Intel® Desktop Board D865PERL Specification Update

Release Date: August 2004

Order Number: C41596-009

Figure 29a. Omnidirectional Airflow Heatsink

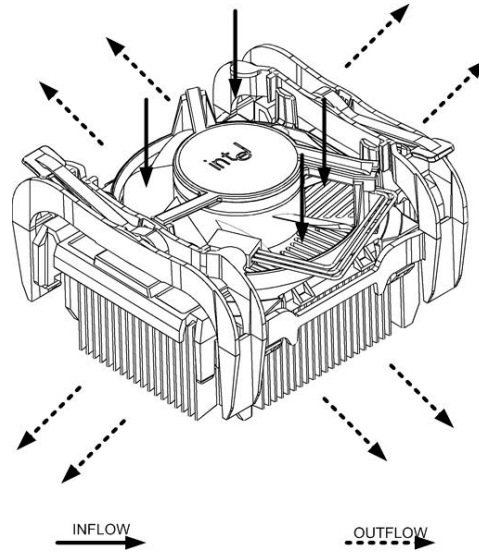
4. **Change to Thermal Considerations, Section 2.12**

The use of an Intel Pentium 4 processor with 1 MB of L2 cache on this Intel desktop board requires the following:

- *A chassis with a maximum internal ambient temperature of 38 Degrees Celsius*
- *A processor heatsink that provides omnidirectional airflow so that air is drawn across the processor voltage regulator area (item A in Figure 30). Figure 29a illustrates an omnidirectional airflow heatsink.*

Figure 30. Localized High Temperature Zones

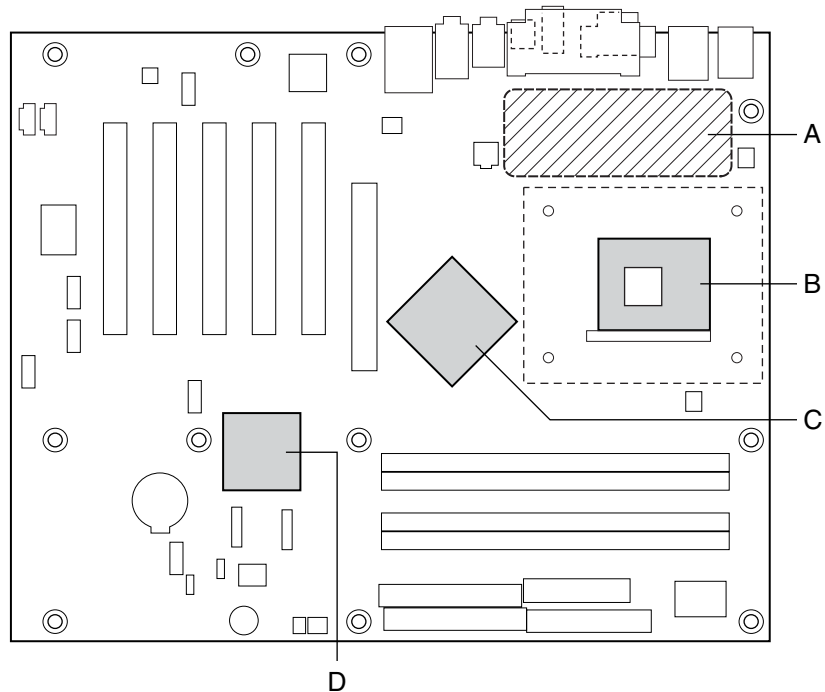
Ensure that proper airflow is maintained in the processor voltage regulator circuit. Failure to do so may result in damage to the voltage regulator circuit. The processor voltage regulator area (item A in Figure 30) can reach a temperature of up to 85 °C in an open chassis.

Figure 30 shows the locations of the localized high temperature zones.
